Preliminary Drainage Report
for
**Windingwalk
and the Enclave
PUD**

MERIDIAN RANCH
A GOLF & RECREATIONAL COMMUNITY

EL PASO COUNTY, COLORADO

PUDSP-18-003

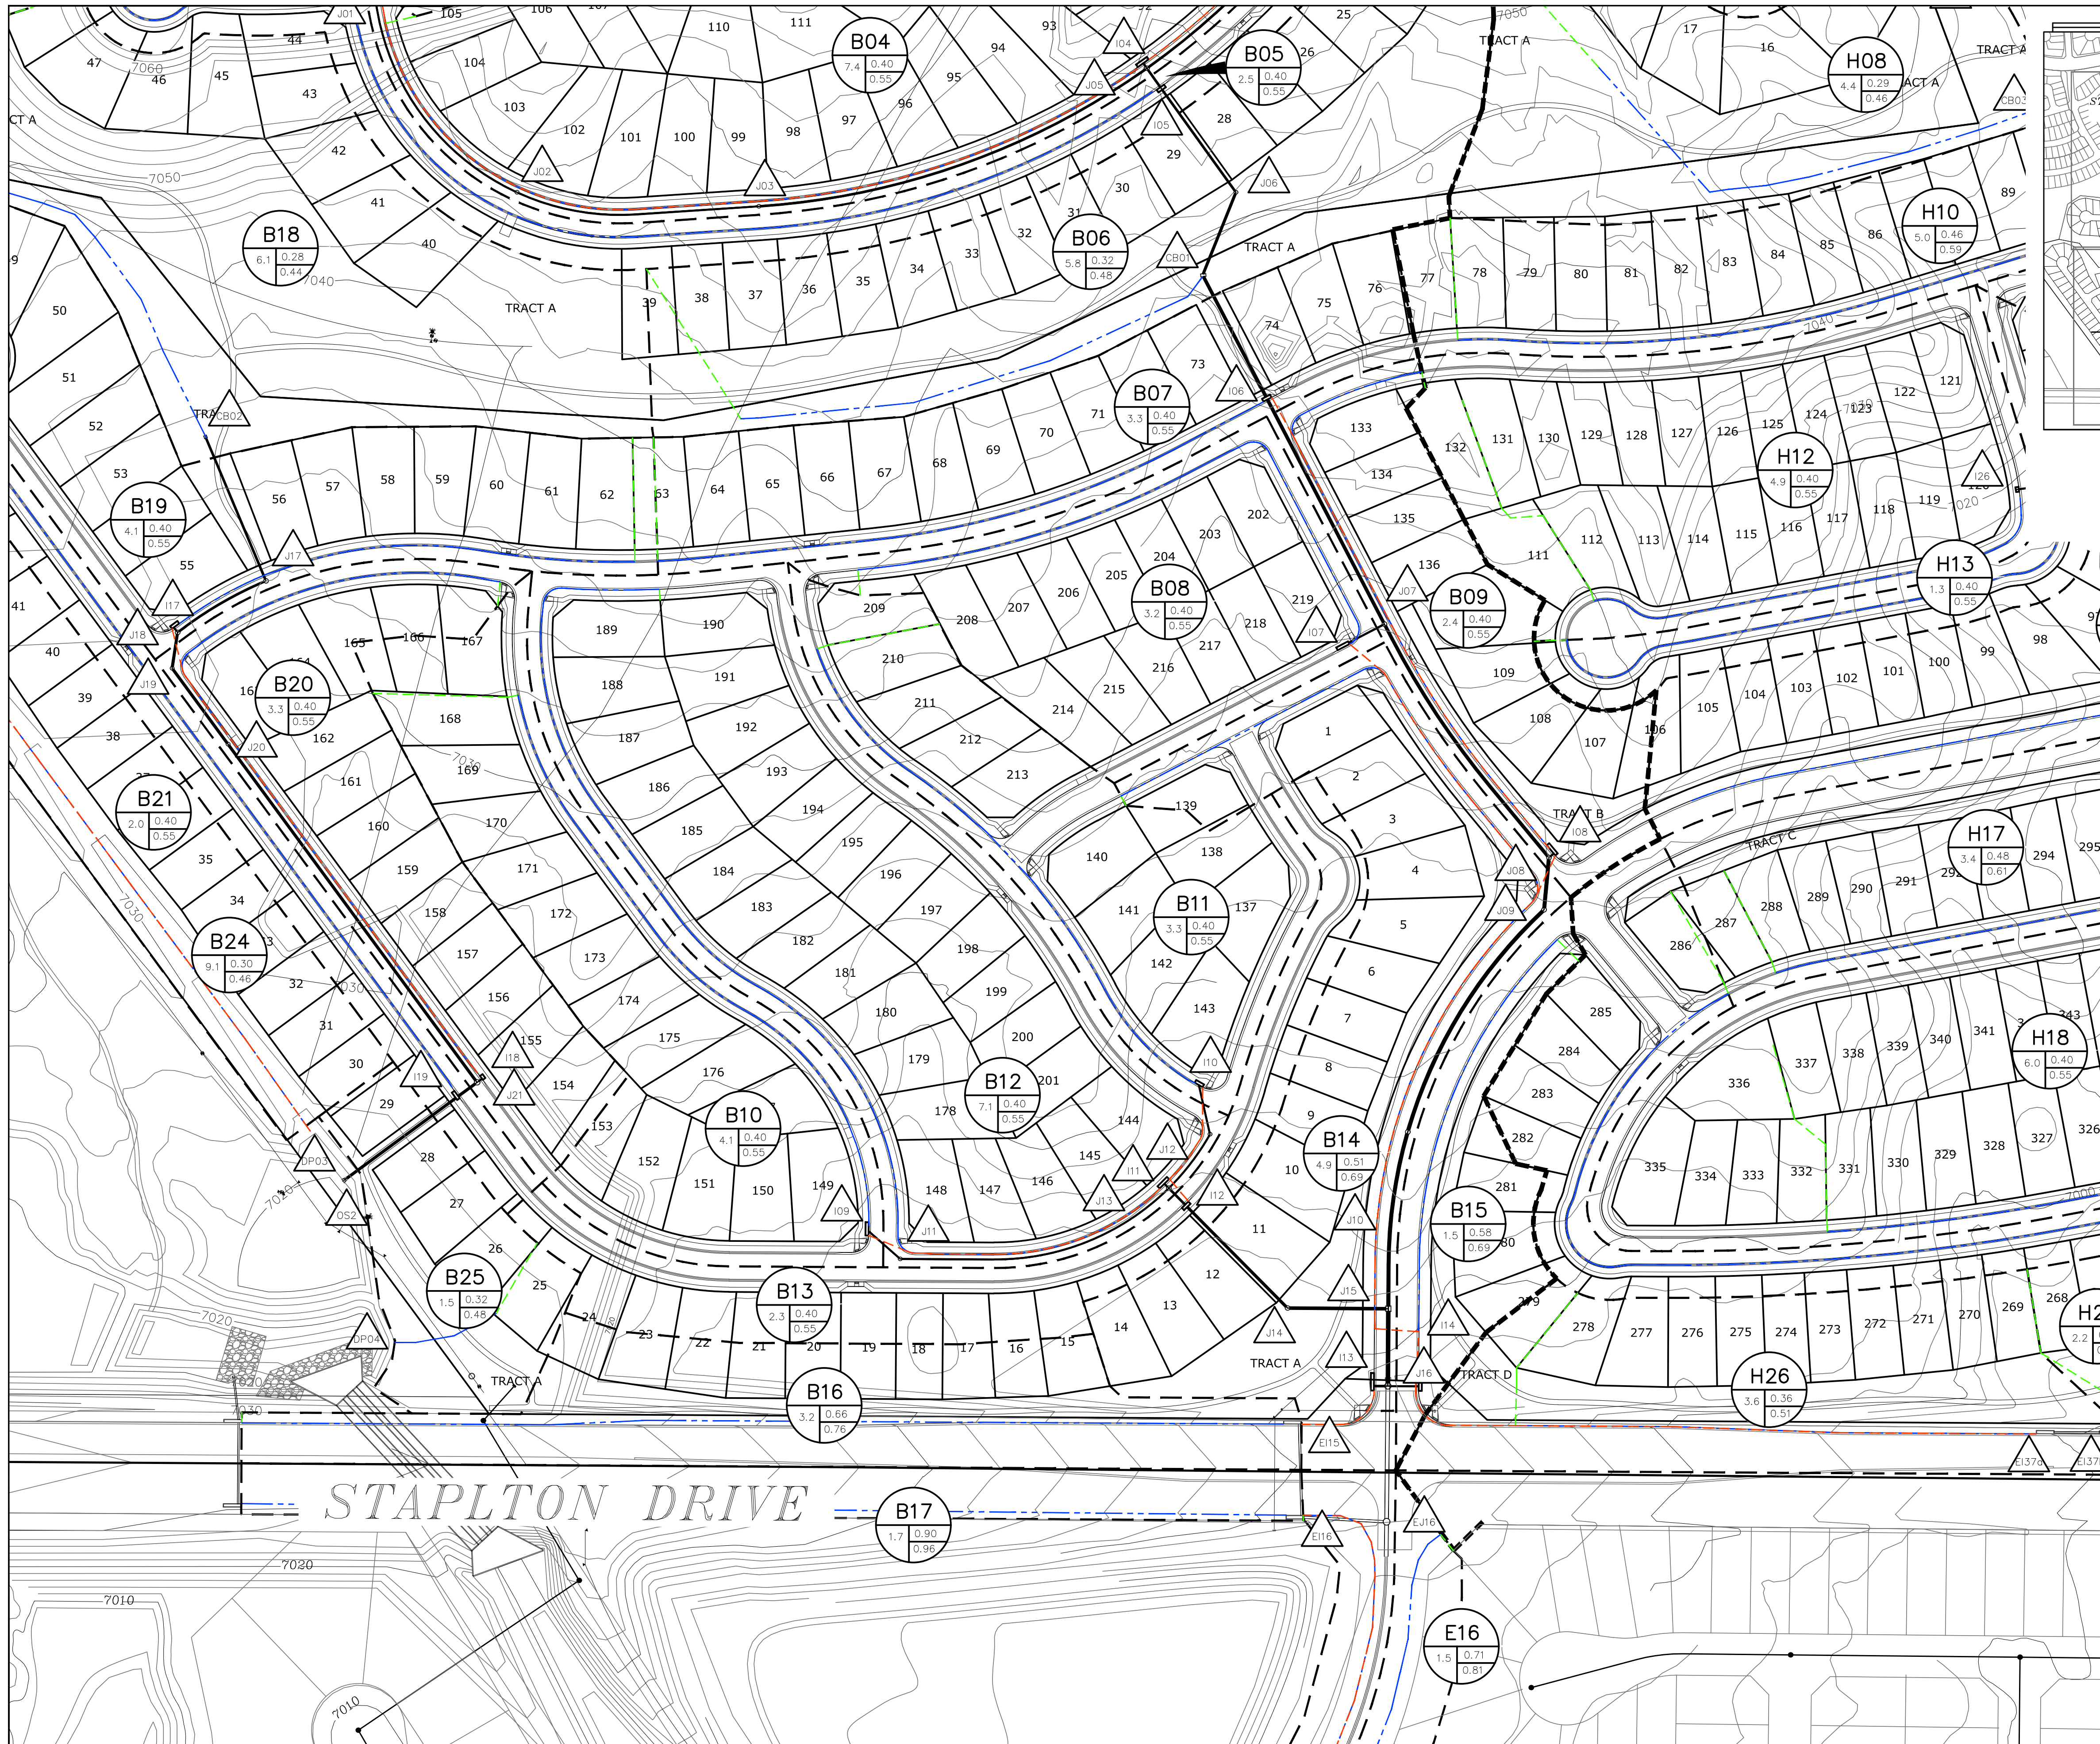
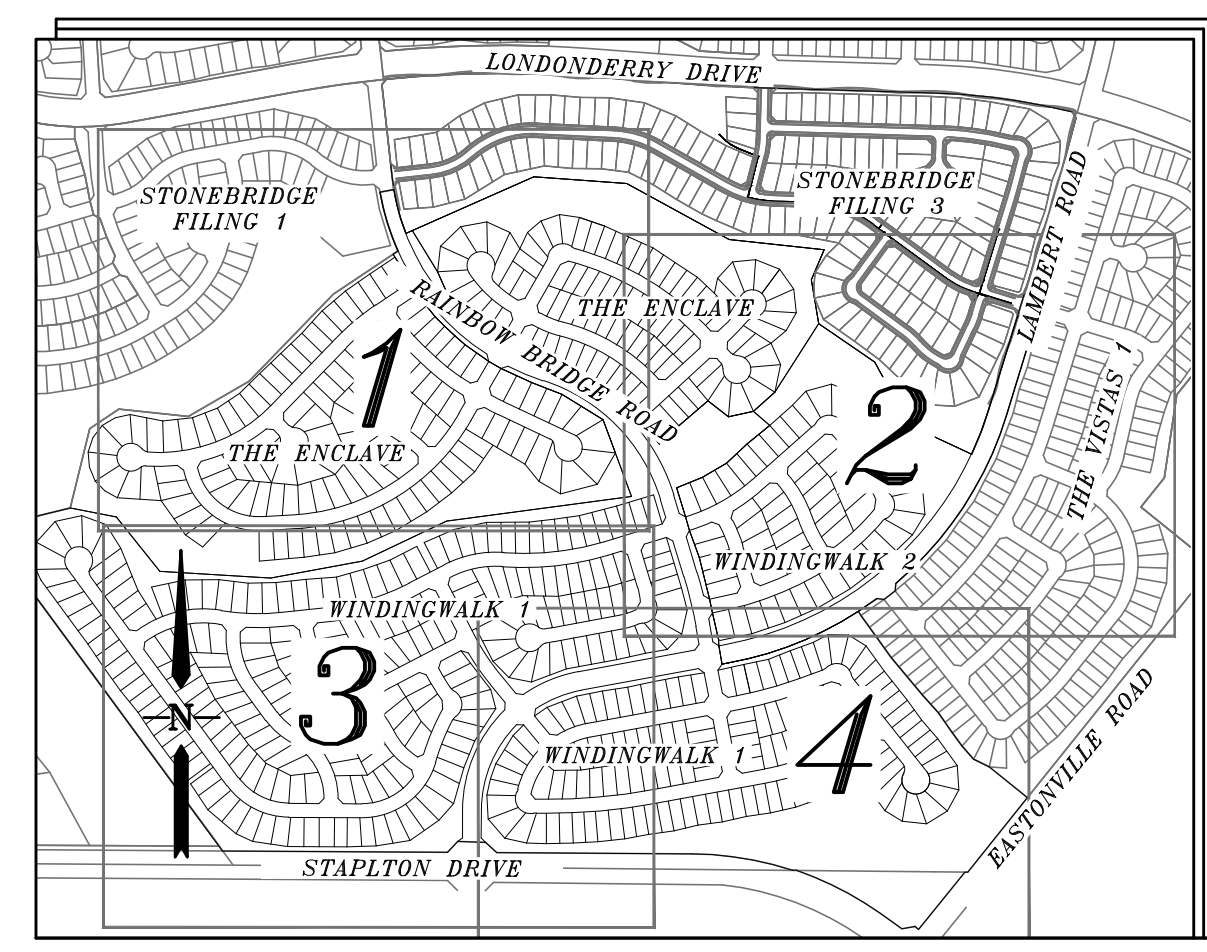
Update the Rational Drainage Map to focus on the Enclaves. Staff recommends adding a callout box on the adjacent filings with reference to their respective PDR/FDR.
Add a summary table of the minor/major flowrates at design points
